SUBJECT: Board Approval of Change Order 1-01, Mechanical Upgrades  
Project 51-23-00-01-0-007-021 OFA

# CHANGE ORDER

No. 1-01

<b>PROJECT:</b> Capital Outlay Project Mechanical Upgrades  <b>OWNER:</b> Ogdensburg City School District 1100 State Street Ogdensburg, New York 13669  <b>CONTRACTOR:</b> Burns Bros. Contractors (Name, Address) 7504 US Rt. 11 Potsdam, NY 13676  <b>CONTRACT FOR:</b> No. 1 - Mechanical  <b>CONTRACT DATE:</b> November 20, 2017	<b>DATE OF ISSUANCE:</b> December 18, 2017  <b>ENGINEER:</b> Bernier Carr & Associates 327 Mullin Street Watertown, New York 13601  <b>ENGINEER'S PROJECT NO.:</b> 2017-021  <b>SED PROJ. MGR.:</b> Sigrid Coons  <b>SED CONTROL NO.:</b> 51-23-00-01-0-007-021 OFA
--	---

**M1-001**  
BID SET

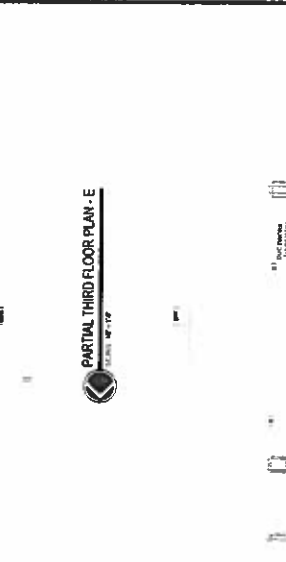
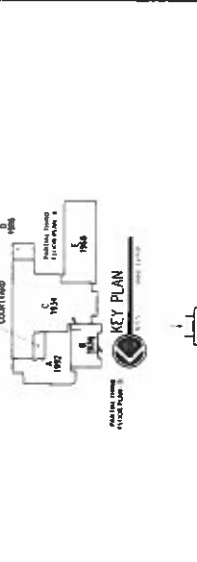
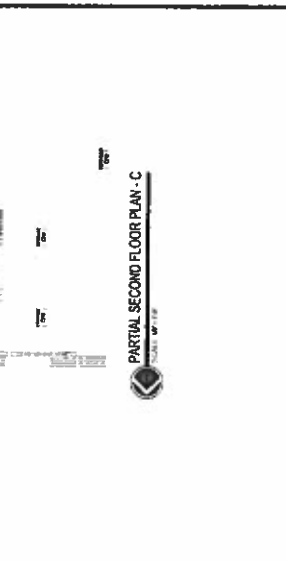
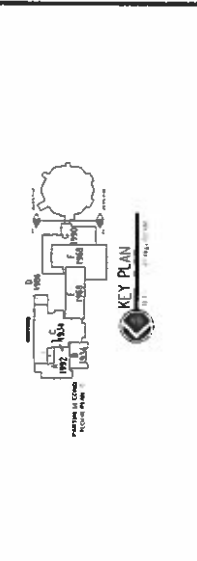
Deduct to eliminate all work associated with the removal of existing classroom unit ventilator, and \$ (7,400.00) installation of new fan coil unit FCU1-1 within Work Room B105 as shown on contracts M1-001 and M1-100.

BURNS BROS CONTRACTORS INC OFFER THE FOLLOWING CREDIT FOR OGDENSBURG  
SCHOOL FCU 1-1 HANGING UNIT IN ROOM B105 PER DRAWING M1-100

A	Owner requested deleted scope of work.
B	As part of the Capital Outlay Project, fan coil FCU1-1 was scheduled for installation within Work Room B105 as per contract drawing M1-001 and M1-100.
C	Upon bidding the project, it was discovered the apparent low bid was higher than anticipated; thereby encumbering most of the schools incidental allowance. As such, the District re-prioritized the replacement of mechanical equipment, and determined the existing classroom unit ventilator within Work Room B105 was adequate in providing their current HVAC needs.
D	Deduct to eliminate all work associated with the removal of existing classroom unit ventilator, and installation of new fan coil unit FCU1-1 within Work Room B105 as shown on contracts M1-001 and M1-100.
